# Ceiling hoist

## Product-information/change GH2

Product-information No. 01-247  
Skejby, Date 29.08.2007

### GH2, GH2+2, GH2+R, GH2+2R & GH2 HD, GH2F Technical change, Fall Protection

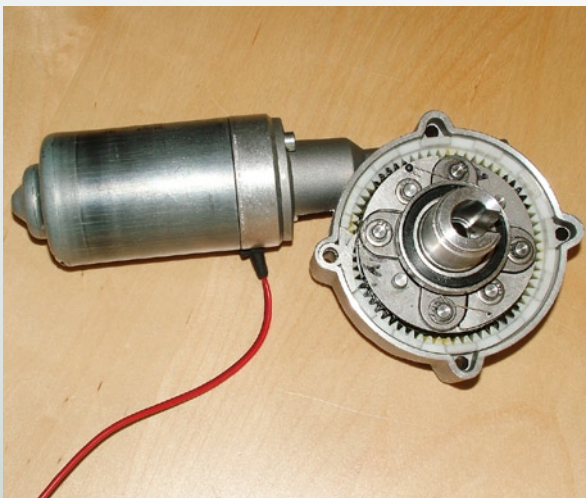
To reach the updated Standard/Norm ISO/EN 10535:2006 (New Version) it has been necessary to implement a fall protection on the motor/gearbox on all hoists in the GH2 family.

The fall protection is placed in the gear box, and works as a wrap spring clutch. That means when the speed of rotation reaches a predefined speed, a special brake will be activated and will stop the hoist (lifting strap) immediately.

Motor for replacement on all GH2 hoists will get a new item number which is 12771-3. This number will replace item number 12771-2.

### This change is applicable from serial numbers

GH2	120001-3549-2007
GH2 HD	120001-2530-2007
GH2 F	120001-1149-2007

**NB:** No changes needed on existing hoists.
